Subject: Junction Rivers Wind Farm (SSD-30448824)

ATTACHMENT A – BCS and NPWS Assessment Summary for Junction Rivers Wind Farm Environmental Impact Statement (SSD-30448824)

ATTACHMENT B – BCS detailed advice for Junction Rivers Wind Farm EIS

Figure 1: Flyway through turbines 26 to 30 and turbines 15 and 75 assessed as low risk but are in a flyway.

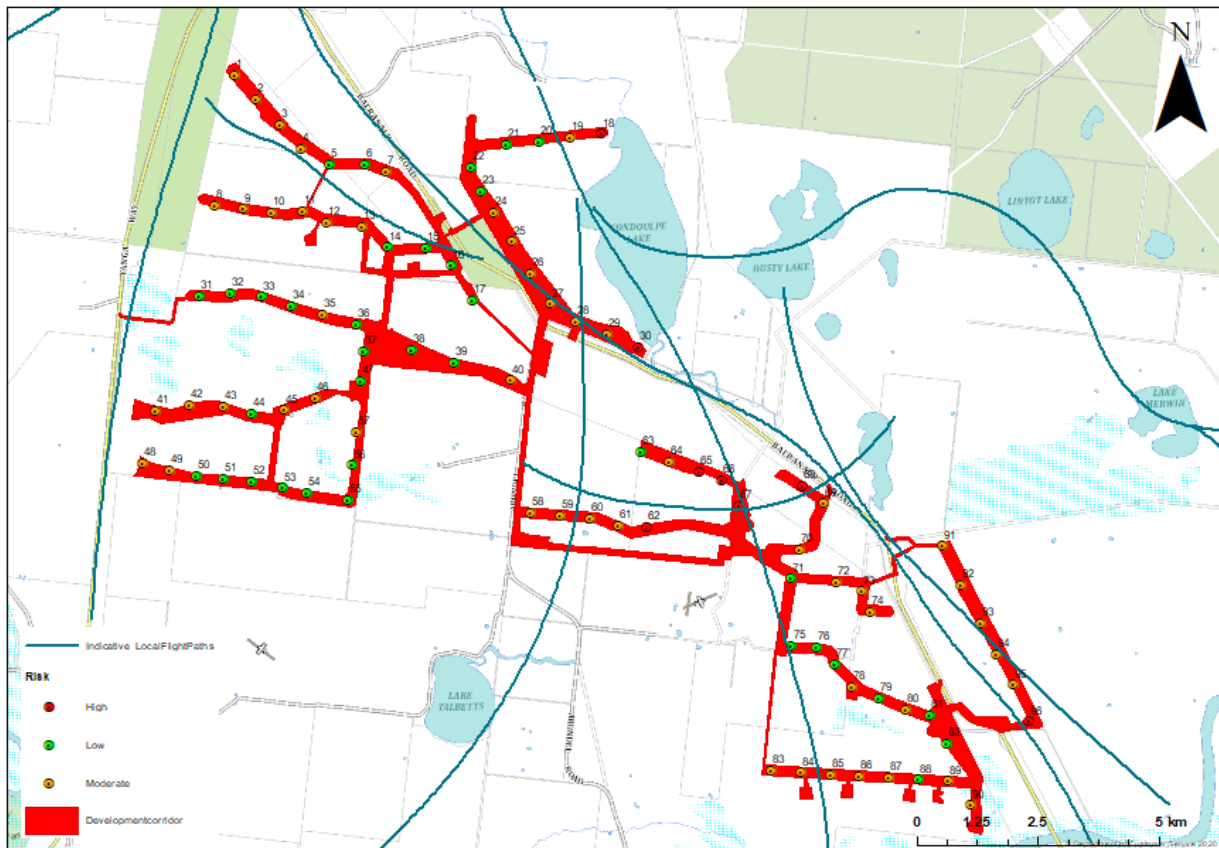
There also appears to be scope for greater avoidance of flight paths and the need to reassess risk ratings based on flight paths. In Figure 1, flyways are very close to several turbines, with one flight path appearing to weave between turbines 26 to 30. Also, turbines 15 and 75 are deemed low risk, yet a flyway passes through them.

Figure 2: Example of areas of native vegetation in the assessment area that have not been included in the calculation of native vegetation in the assessment area.

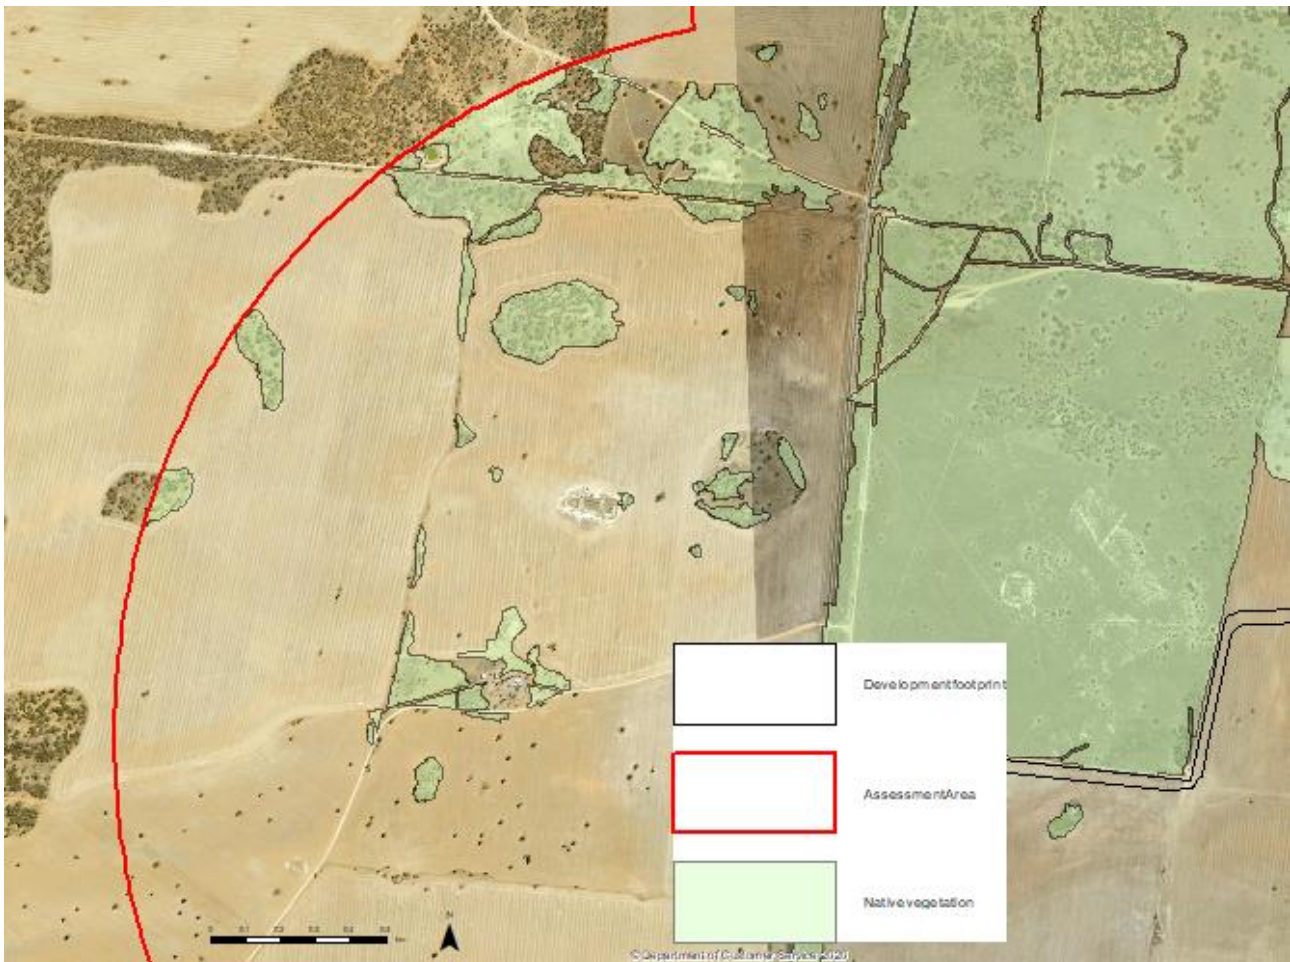
Section 2.1.1 and Figure 5.1 of the BDAR identifies the native woody and non-woody vegetation in the assessment area for the proposed development. The full extent of native vegetation, which includes scattered trees and remnant native vegetation, has not been mapped (see example in Figure 2). In addition to derived, remnant and regrowth native vegetation, the native vegetation cover should also include planted native vegetation in accordance with section 3.2 of the BAM Operational Manual - Stage 1.

We note that the native vegetation extent is 29.43% which means it is in the lower (0-30%) category. The omission of some of the native vegetation extent from the assessment area may mean the assessment area should be >30% and be in the next category of >30% to 70% cover, which could trigger changes to the predicted and candidate species lists in the BAM-C. Accurate calculation of native vegetation cover is required to inform the habitat suitability assessment for predicted and candidate species in the BAM-C.

- 13.1. Review native vegetation cover in the assessment area to include all woody and non-woody native vegetation (including planted native vegetation).
- 13.2. Once complete, review the native vegetation percent cover and if required update the BAM-C and the BDAR, and address any changes to predicted and candidate species if triggered by a higher percent cover category.
